# SPRINGDALE

## **Memorandum**

**To:** Planning Commission  
**From:** Niall Connolly, Principal Planner  
**Date:** June 13th 2025  
**Re:** Erosion Hazard Zone Permit, 517 Watchman Drive

# EROSION HAZARD ASSESSMENT

**Figure 1. Aerial view of the property, with the erosion hazard zones overlaid.**

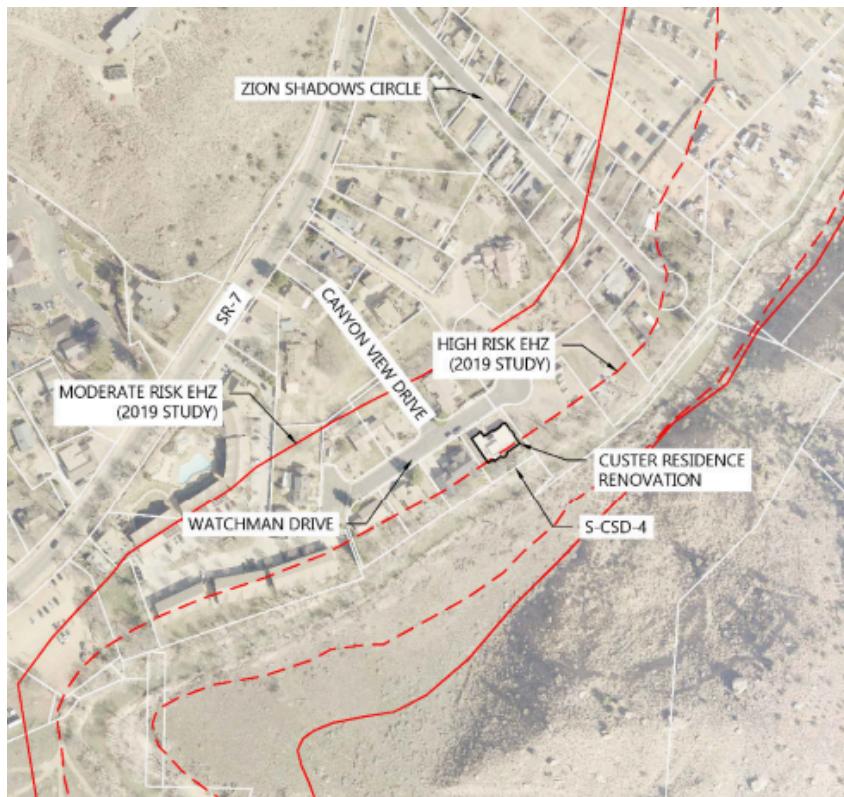
The study examined the existing bank armoring in this location, as well as the dynamics of the river which affect this property. The study found that the bank has been stable at this location for many years, and it is likely that the existing armoring has contributed to that. The armoring consists of boulders keyed into the bank, along with mature vegetation. The bank armoring includes concrete grout to keep

the boulders in position. In some cases, the grout has eroded and a boulder has been lost. However, on the whole, the bank is in good condition. The study does not recommend any interventions at this point. It does recommend that the property owners should monitor the condition of the bank over time, and that maintenance may be needed in the future. This would likely involve renewing the grout between the boulders. Concrete grout is not considered “bioengineering” and generally would be discouraged by the Town in new erosion protection projects. However, because the bank armor has already been built that way, it will be necessary to use concrete grout in future repairs. The property owner will need Town approval for any repairs or improvements that may be necessary in the future.
